TOWN OF LUNENBURG

WASTEWATER TREATMENT PLANT UPGRADES & EXPANSION

CONTRACT NO. 240800.00

ADDENDUM NO. 1

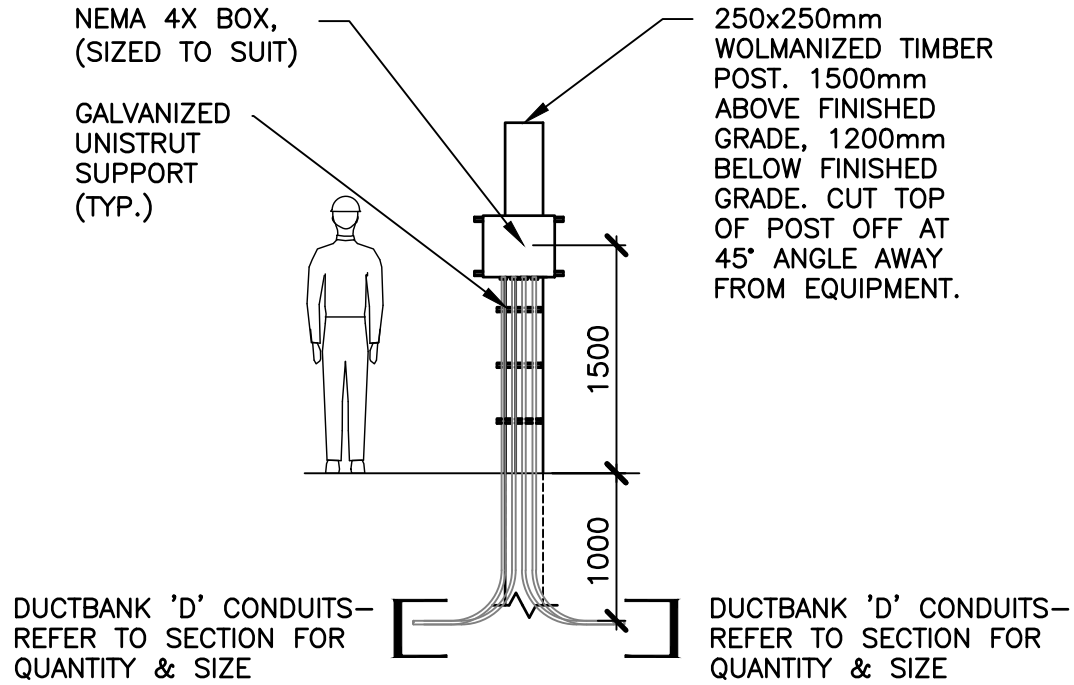
**Delete 240800.00-J05 and replace with new 240800.00-J05, attached.**

Date JAN 07/25	Scale N.T.S.	Designed JRK	Drawn IGG	Checked LH	Approved SHE	CBCL No. 240800.00	Contract -
						TOWN OF LUNENBURG WASTEWATER TREATMENT PLANT UPGRADES & EXPANSION Drawing	
JUNCTION BOX POST DETAIL						<h1>ESK-01</h1>	
1	ISSUED FOR ADDENDUM NO. 1						
No.	Description

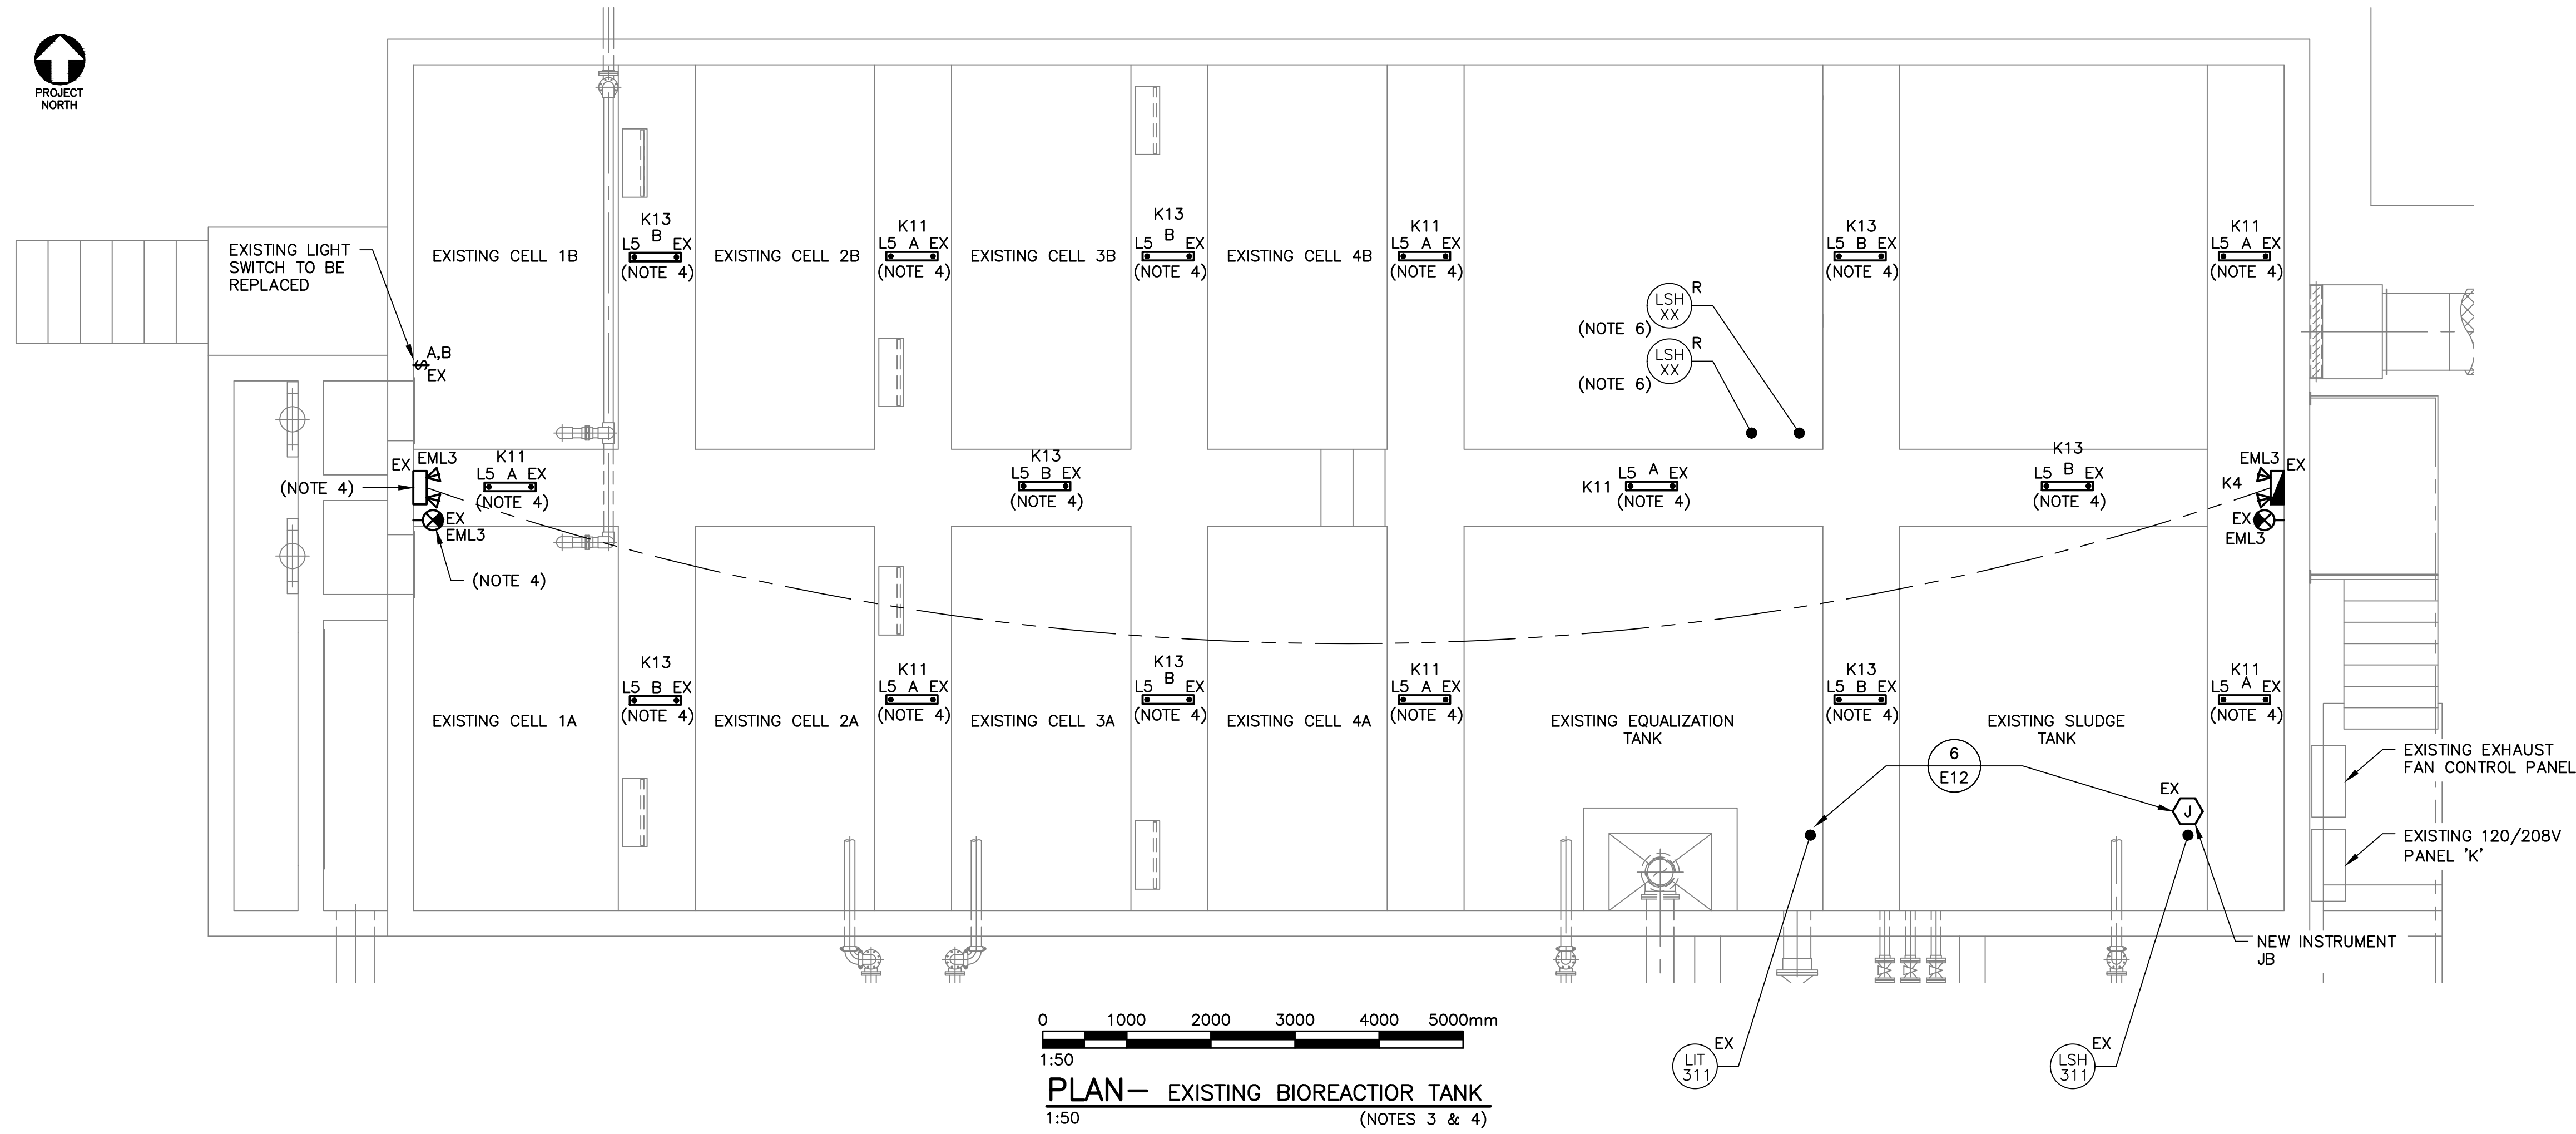
Add new Sketch ESK-01 – Junction Box Post Detail dated January 7, 2024, attached.

Change “JUNCTION BOX” SYMBOL SHOWN ON DUCTBANK ‘J’ to “PULL BOX” LOCATED BY THE EXISTING BIOFILTER PAD. Add the following note to Detail 1 “REFER TO SKETCH ESK-01 FOR MOUNTING REQUIREMENTS”.
